## Furtho Pit, Cosgrove, Northamptonshire: Review of Application Documents Relating to Hydrology and Flood Risk.

**January 2026**  
**Version 4: Amended Final Report.**

## Executive Summary

Figure 1. EA medium and high-risk flood zones shown in blue for the wider area around the development site (outlined in red).

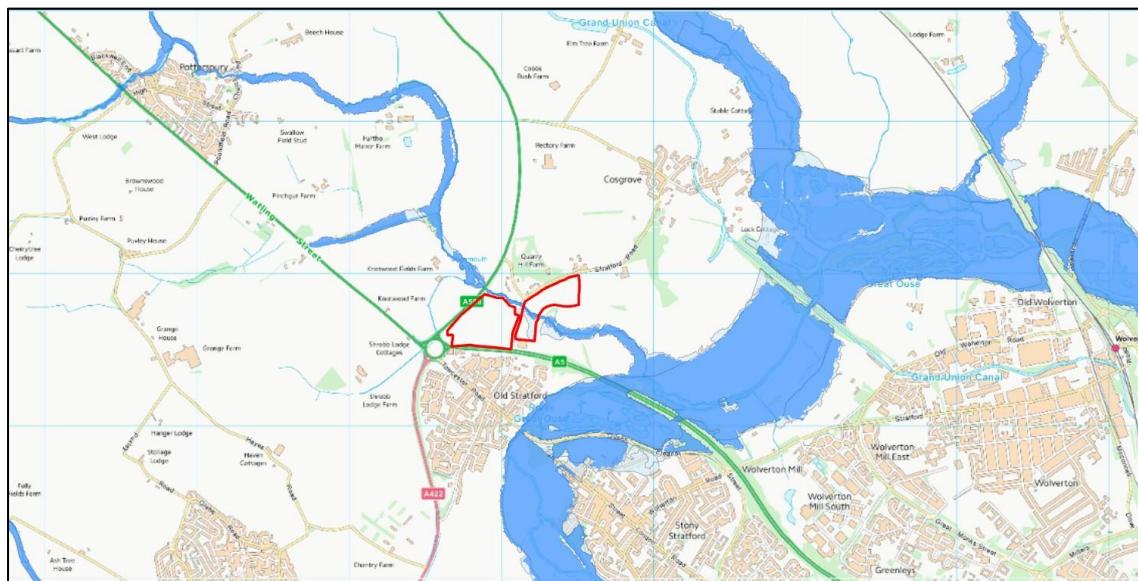
The Plan has not covered the hazard from flooding over the wider area. As it is a commercial site, staff would travel from their place of residence to and from the site, and it is likely that the day-to-day activities at the site would involve delivery and shipment of goods. The staff should be made aware of this as the flooding over the wider area could restrict movement to and from the site, as the map in Figure 1 shows with flood zone 3 covering the A5 areas of Stony Stratford to the south-east and also Watling Street to the north-west. The fact that the large extent of flooding from the River Ouse to the south-east will also have consequences on the operation of the site seems not to have been fully considered in the development proposals.
